LOCATION: Elam Road at Elwayne Avenue, northeast corner

REQUEST: An application to create one 0.175-acre (7,600-square foot) lot and one 0.285-acre (12,400-square foot) lot from 0.459-acre tract of land in City Block 6250 on property located on Elam Road at Elwayne Avenue, northeast corner.

Case no: S234-162

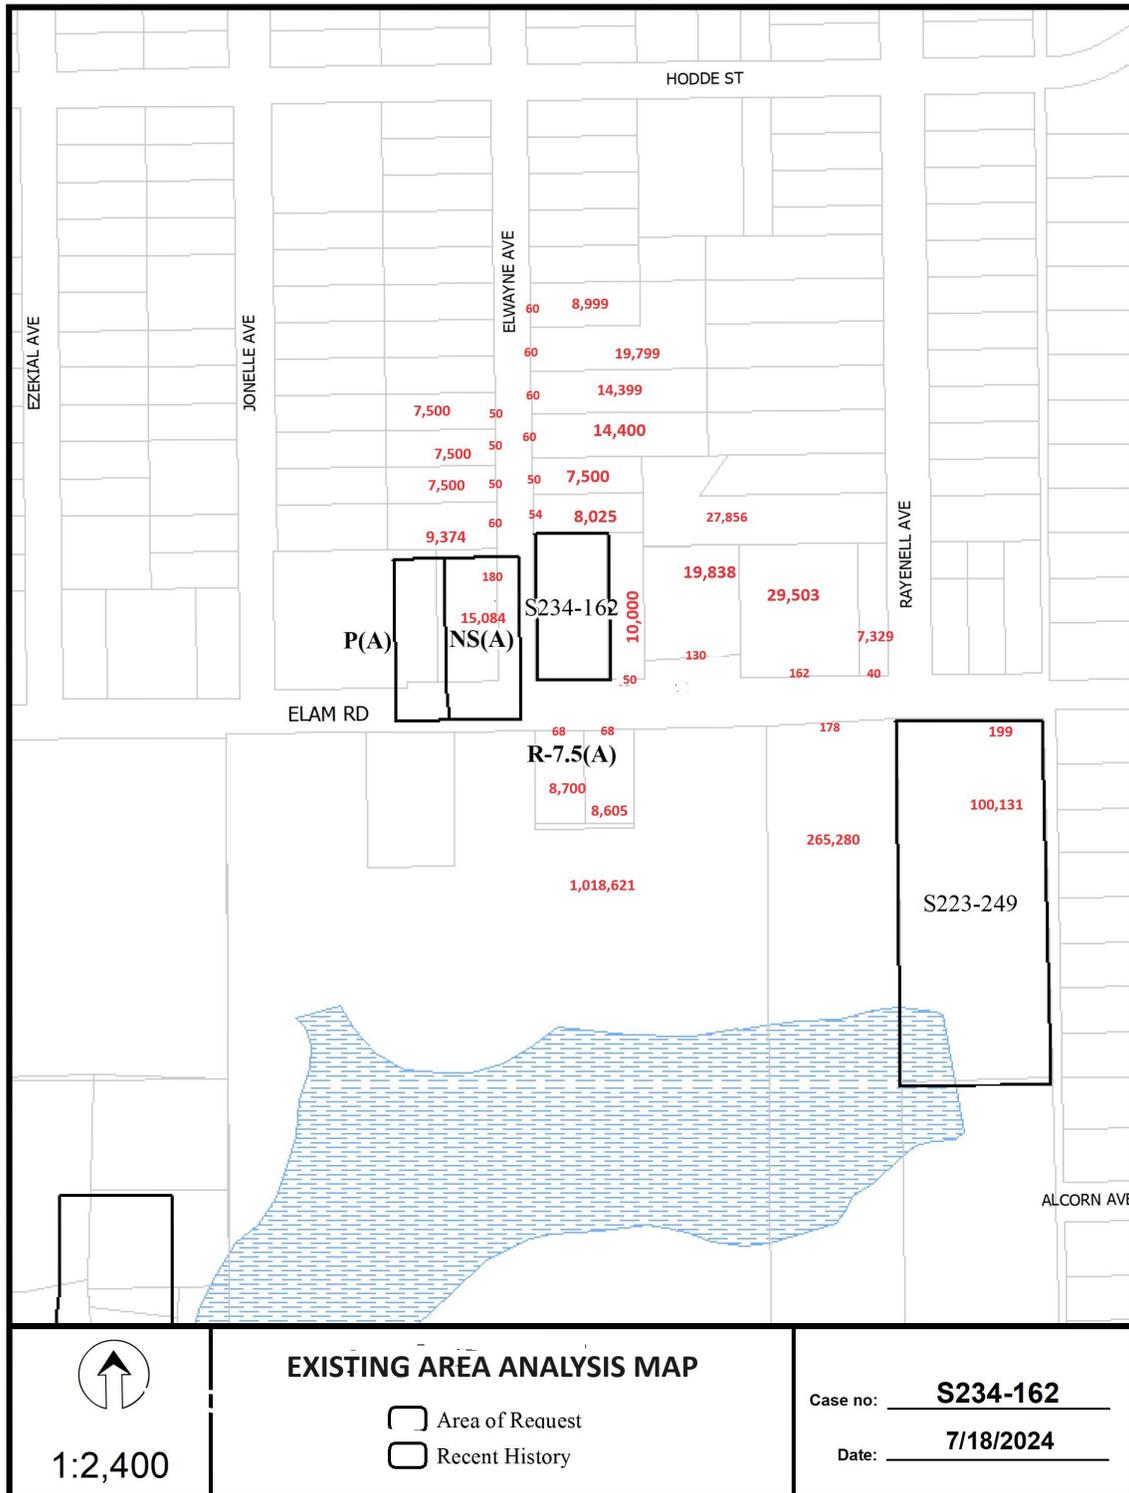
19. Prior to final plat, submit a completed final plat checklist and all supporting documents.
20. On the final plat, show the correct recording information for the subject property. Platting Guidelines.
21. On the final plat, all access easement(s) must be recorded by separate instrument(s) and the recording information must be shown on the final plat. Platting Guidelines.
22. On the final plat, show all additions or tracts of land within 150 feet of the property with recording information. Platting Guidelines.
23. On the final plat, address if there is possible storm drain crossing southwest corner of property.
24. On the final plat, remove lot & block from plat name in Owners Dedication.
